VALLEJO ARCHITECTURAL HERITAGE AND LANDMARKS COMMISSION REGULAR MEETING – 6:30 P.M. CITY COUNCIL CHAMBERS May 18, 2023

- A. PROJECT NUMBER:** Certificate of Appropriateness (COA) #22-0005
- PREPARED BY:** Cesar Orozco, Principal Planner
- PROJECT LOCATION:** 717 - 719 Sacramento Street / APN: 0055-126-110
- APPLICABLE ZONING** Residential Low Density

DATE OF MEETING:	May 18, 2023
PROJECT NUMBER:	Certificate of Appropriateness (COA) #22-0005
PREPARED BY:	Cesar Orozco, Principal Planner
PROJECT LOCATION:	717 - 719 Sacramento Street / APN: 0055-126-110
APPLICABLE ZONING CODE SECTION(S):	Certificate of Appropriateness (Vallejo Municipal Code (VMC) Section 16.614.09)
PROJECT SUMMARY:	The project involves exterior alterations to an existing single-family residence converted to a duplex unlawfully without permits. The project proposes to bring the single-family residence into compliance with the building code and add an accessory dwelling unit (ADU) and a junior accessory dwelling unit (JADU), all within the existing building envelope. The proposed ADU and JADU are subject to ministerial approval under Government Code Section 65852.2. To accommodate the proposed interior floor plan chan

EAST ELEVATION

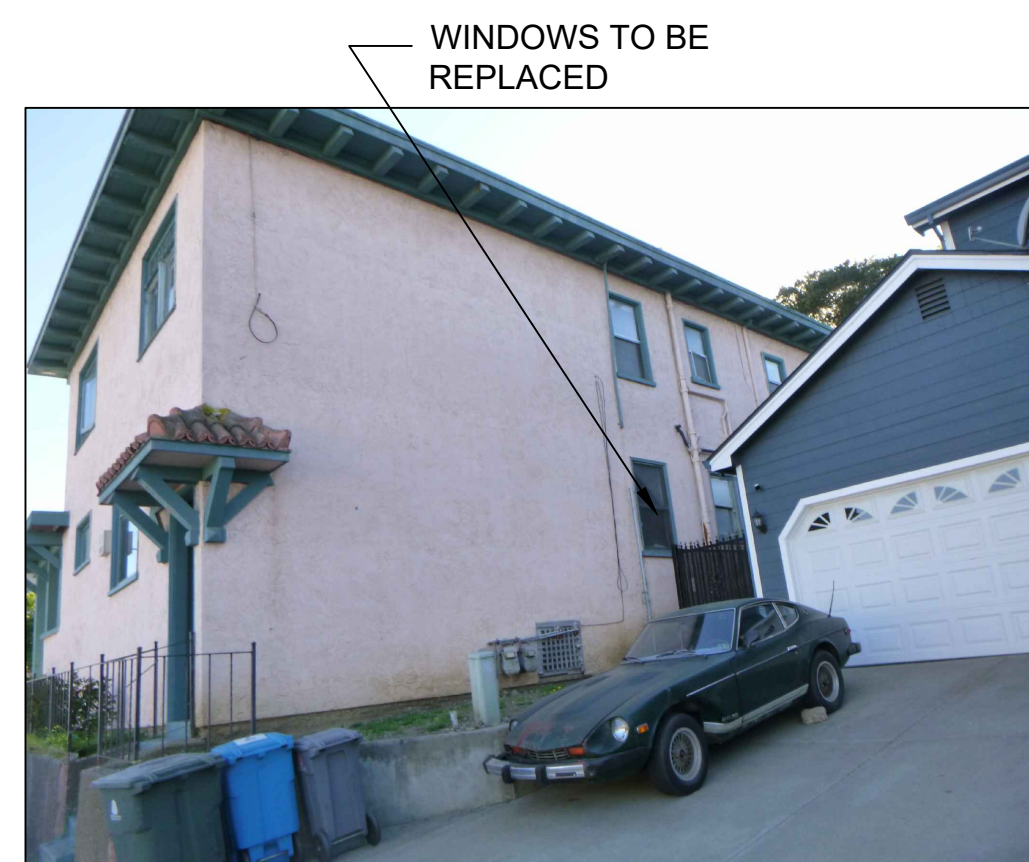
On the primary elevation that faces Sacramento Street (see Figure 2) , two first-floor level windows are proposed to be removed and have their opening altered. The original wood frame windows on the east elevation include a small, wood sash window and one fixed pane window with divided lite transom. The architectural historian found that these elements are character-defining features of the building on a primary elevation and the modifications to the openings and the removal of the windows would impair the property's historic character (see Figure 3).

As noted in the report, *original materials particularly those on primary elevations, should be retained as these elevations are visible to the public right-of-way. The proposed modification for the two windows on the east (primary) elevation is inconsistent with Standard No. 2 of the Standards of Rehabilitation. In order to conform to the Standards, removal of the windows should be avoided or should be replaced in-kind with retention of the divided lite transom. If replacement is needed to meet compliance for egress, the original openings and transom should be maintained, and sash windows installed.*

The proposed plans include removal of two original windows, identified as character-defining features of the property, on the east elevation, and alteration of the openings through the removal of stucco and interior wood framing, and replacement with wood vertical sash windows. Removal of the windows would not comply with Rehabilitation Standard No. 5. To conform with the Standards, it is recommended that the windows be retained or replaced in-kind. If replacement is needed to meet compliance for egress, the original openings and transom should be maintained and one-over-one sash windows installed. Their removal, therefore, is inconsistent with Rehabilitation Standard No. 5.

After speaking with the applicant, the property owner has agreed to follow the consultant's recommendation of retaining the fixed pane window with the divided lite transom and replacing the smaller wood sash window with a sash window. The existing window openings will not be enlarged. With that modification, the scope of the project is consistent with the Department of Interior Standard No 2. as required in the Findings attached in Attachment 1. This agreement has been reflected in the conditions of approval.

SOUTH ELEVATION
UNPERMITTED WORK

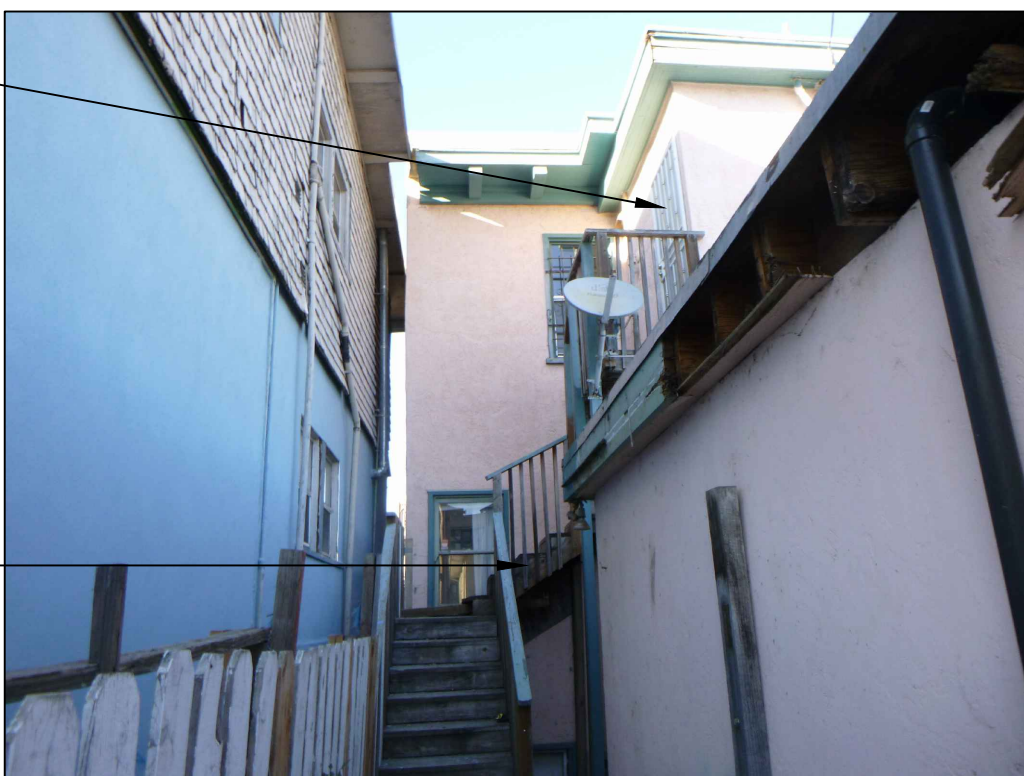
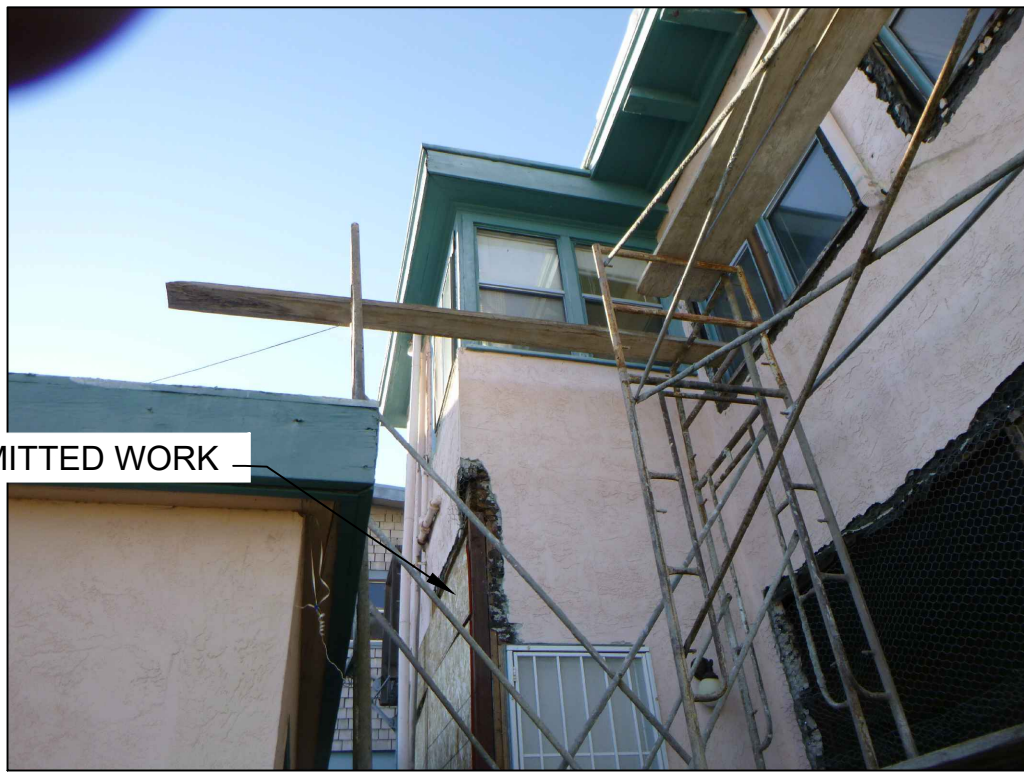
On the south elevation's first floor, two large openings from unpermitted work are proposed to receive new windows. The western opening is proposed to receive a wood frame horizontal sliding sash window while the eastern opening will have a portion of its sill raised for a smaller opening and receive a wood frame one-over-one sash window and a fixed wood frame window. The proposed windowsill modification for a smaller window is designed to accommodate the height of a kitchen counter at the interior and as previously described, will generally maintain the rhythm of fenestration on this elevation, despite proposed changes to the opening. The small wood fixed window and the wood frame one-over-one sash windows are compatible as the building currently exhibits this style of windows and is consistent with the building's historic character. Horizontal sliding sash windows were not, however, common when the building was constructed. Two paired one-over-one sash windows on the second floor above, suggest the first floor likely repeated the same historic configuration. It is recommended, that the western window opening receive paired one-over-one windows instead of a horizontal sliding sash window to reflect the historic configuration. The proposed window replacement at the south elevation generally meets Standard No. 9. However, the proposed sliding horizontal sash window is recommended to be replaced with paired one-over-one wood sash windows in order to more successfully conform to Standard No. 9.
